Confey Lands 1A LRD

Combined Stage 1 & 2 Road Safety Audit

April 2026

Figure 2.1 – Locations of Where Cyclists Will Be Required Transition Back into Traffic Lanes

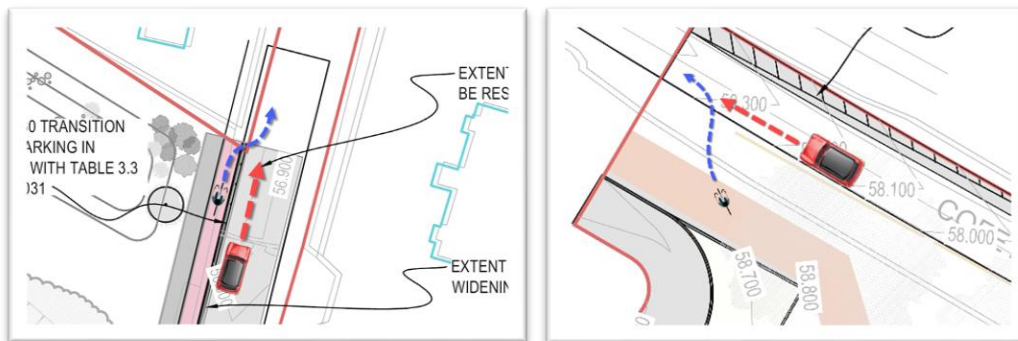
2.1 Problem: Cyclists Rejoining Traffic Lanes Suddenly

Location: Cycle Tracks on R149 Captains Hill and L1015 Confey Road

When cyclists reach the end of the segregated cycling tracks, they will merge into adjacent traffic lanes unexpectedly, which could increase the risk of them being struck from behind by approaching vehicles.

Cyclists should be provided with a safe and appropriate means to transition back into the adjacent traffic lane. The measures should highlight to drivers the location where cyclists will be re-entering the traffic lane in front of them.

Problem Reference (Section 2)	Designer Response Section			Audit Team Response Section
	Problem Accepted (yes / no)	Recommended Measure Accepted (yes / no)	Alternative Measures or Comments	Alternative Measures Accepted (yes / no)
2.1	YES	YES	Along the East of the site, a transition arrangement in accordance with The Cycle Design Manual is provided in the interim, prior to the completion of the Confey Masterplan and associated future road upgrade. Upon completion of the masterplan, dedicated cyclist and pedestrian facilities will be developed further.  Similarly, In the Interim and prior to the Confey Masterplan being completed, a shared surface with tactile paving and dropped kerb is provided for a transition to the carriageway. 	Comment noted.
2.2	YES	YES	Parallel Parking along carriageways have been relocated/ amended to accommodate suitable visibility splays	Comment noted.

Figure 2.2 – Examples of Internal Junctions with Parking Close By Which Might Impact on Sightlines

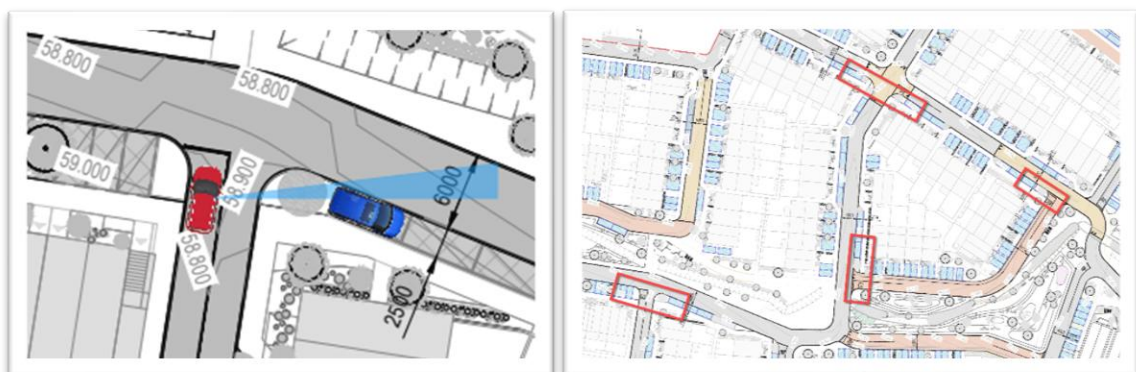
2.2 Problem: Parking Beside Junctions Obscuring Lines of Sight

Location: Various Junctions within the Development Internal Streets

Parking bays positioned too close to internal junctions may reduce visibility splays, increasing the risk of side impact type collisions on the internal streets.

Sightlines for all internal junctions with parking close by should be examined, with the parking arrangements modified as appropriate to achieve suitable sightlines.

Figure 2.3 – Uncatered Pedestrian Crossing Desire Lines at Internal Junctions

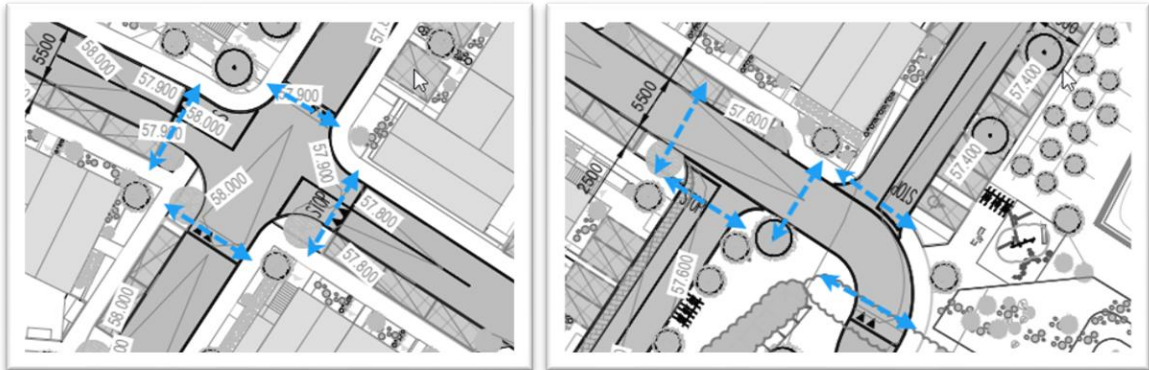
2.3 Problem: Uncatered Pedestrian Crossing Desire Lines

Location: Various Junctions within the Development Internal Streets

At a number of internal junctions there appears to be an absence of crossing facilities. This could lead to pedestrians attempting to cross the road at unsuitable locations placing them in conflict with vehicles.

Suitable raised pedestrian crossings should be provided in all locations where pedestrians are likely to want to cross the internal streets.

Problem Reference (Section 2)	Designer Response Section			Audit Team Response Section
	Problem Accepted (yes / no)	Recommended Measure Accepted (yes / no)	Alternative Measures or Comments	Alternative Measures Accepted (yes / no)
			given the slower speeds through the internal road network 	
2.3	YES	YES	Additional Pedestrian Crossing points have been added where pedestrians will cross internal streets. 	Comment noted.
2.4	YES	YES	Landscaped connection has been provided from the units to the eastern portion of the site 	Comment noted.
